Subject: Duke Energy Carolinas, LLC.
William States Lee III Nuclear Station - Docket Nos. 52-018 and 52-019
AP1000 Combined License Application for the
William States Lee III Nuclear Station Units 1 and 2
Partial Response to Request for Additional Information
(RAI Nos. 820, 821, 822, 823, 824, and 825)
Ltr# WLG2008.10-14

Lee Nuclear Station Response to Request for Additional Information (RAI)

RAI Letter No. 017

NRC Technical Review Branch: Hydrologic Engineering Branch (RHEB)

2.4.4-201

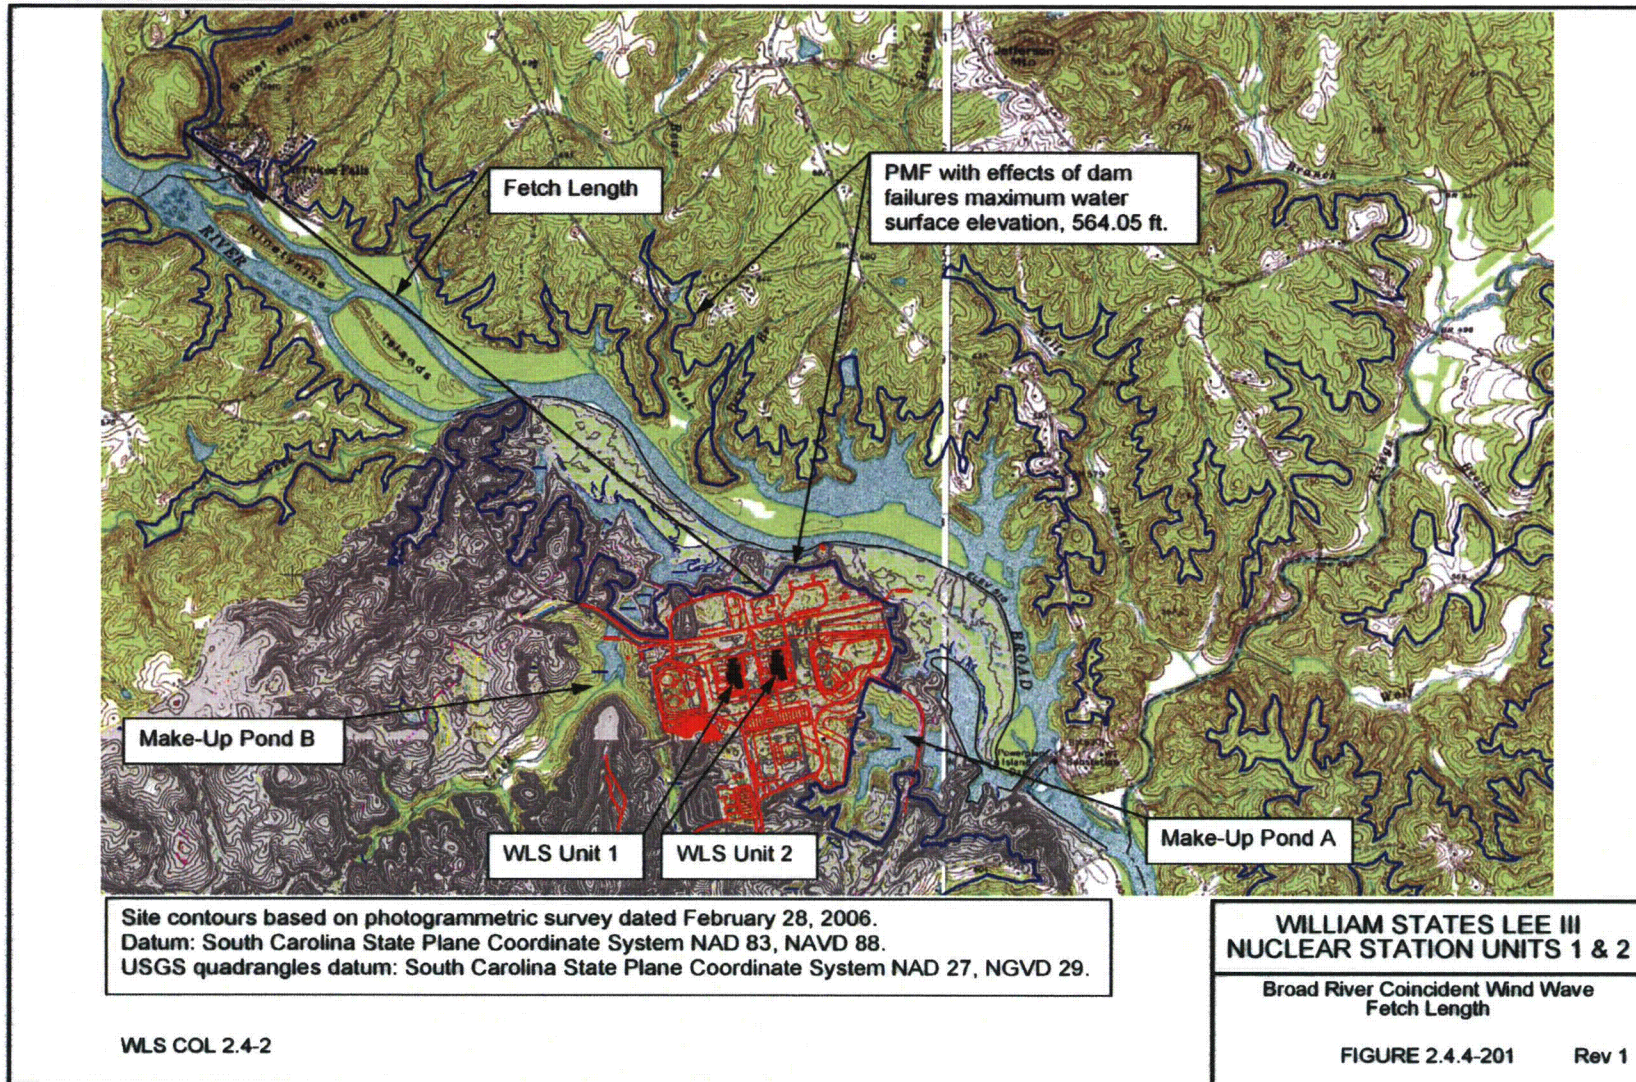
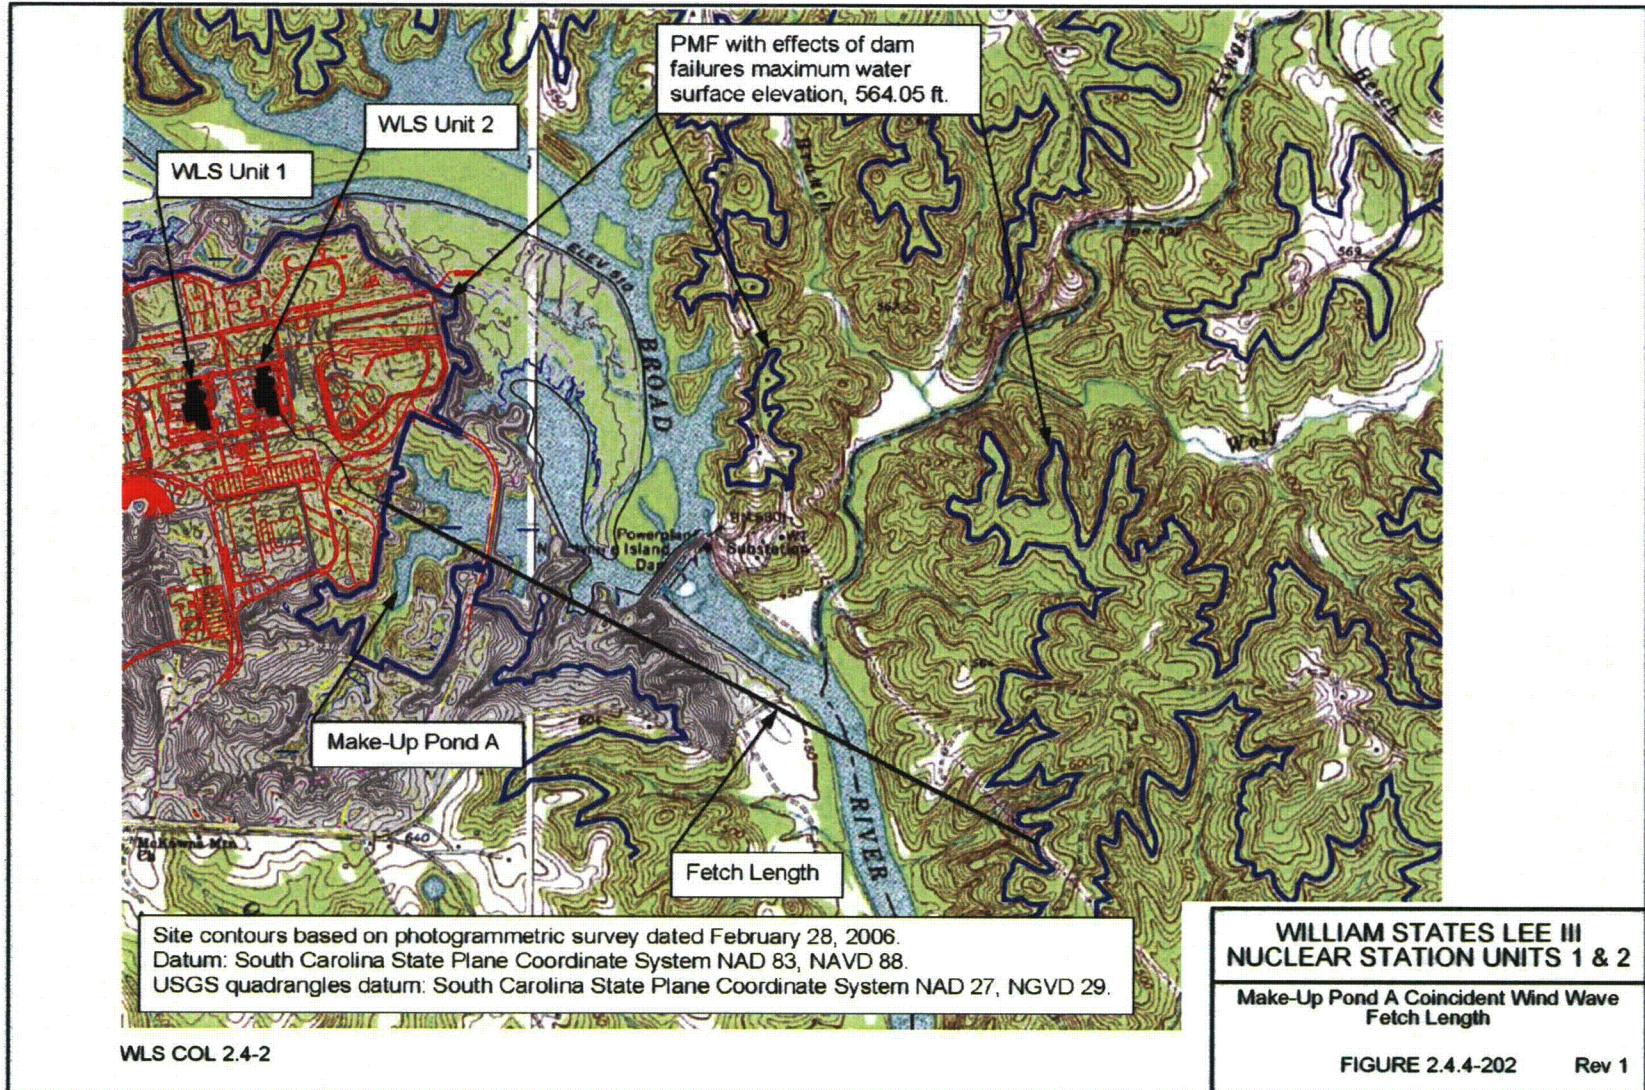
Provide wind-induced wave heights coincident with the controlling dam breach flooding scenario described in FSAR Section 2.4.4.

Wind wave activity on the Broad River is evaluated coincident with the maximum water surface elevation of the PMF including the effects of dam failures as discussed above. The determined critical fetch length of 2.75 mi. is shown in Figure 2.4.4-201. The 2-year annual extreme mile wind speed is adjusted based on the factors of fetch length, level overland or over water, critical duration, and stability. The critical duration is approximately 56 min. The adjusted wind speed is 49.9 mph.

During severe flooding events, Make-Up Pond A is inundated by backwaters of flooding of the Broad River. Therefore, wind wave activity on Make-Up Pond A is evaluated coincident with the maximum water surface elevation of the PMF on the Broad River including the effects of dam failures as discussed above. The determined critical fetch length of 1.69 mi. is shown in Figure 2.4.4-202. The 2-year annual extreme mile wind speed is adjusted based on the factors of fetch length, level overland or over water, critical duration, and stability. The critical duration is approximately 39 min. The adjusted wind speed is 50.2 mph.

FSAR Figure 2.4.5-201

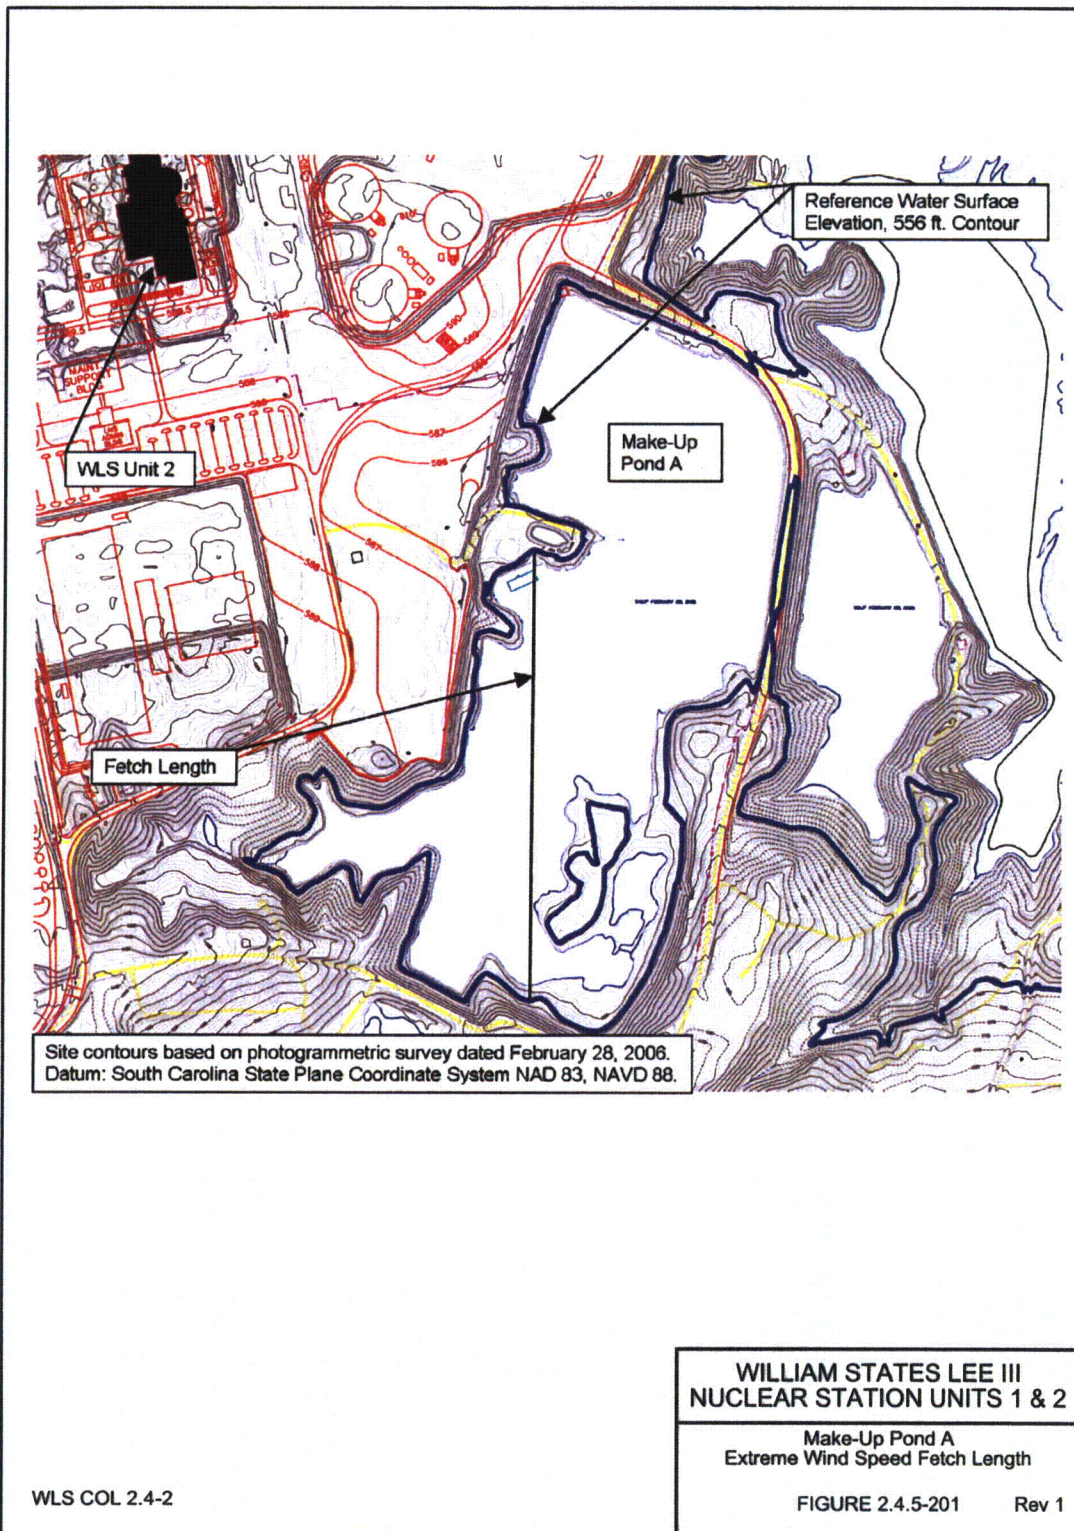
Provide an assessment of meteorologically and seismically-induced seiches in Make-Up Ponds A and B.

Make-Up Pond A surge flooding is evaluated coincident with the 100-yr. water surface elevation of 556.07 ft. The critical fetch length is 0.37 mi. as shown in Figure 2.4.5-201. The wind speed is adjusted based on the factors of fetch length, level overland or over water, critical duration, and stability using U.S. Army Corps of Engineers guidance (Reference 295). The critical duration is 10 min. The adjusted wind speed is 97.4 mph.

The slopes along the banks of Make-Up Pond A adjacent to the site area are approximately 52 percent at most and are used to determine the wave setup and runup. The maximum runup, including wave setup, is estimated to be 8.79 ft. The maximum wind setup is estimated to be 0.08 ft. Therefore, the total water surface elevation increase due to high speed wind wave activity is estimated to be 8.87 ft. The resulting flood elevation is 565.0 ft. The Lee Nuclear Station safety-related plant elevation is 590 ft. and is unaffected by high speed wind wave activity flooding conditions.
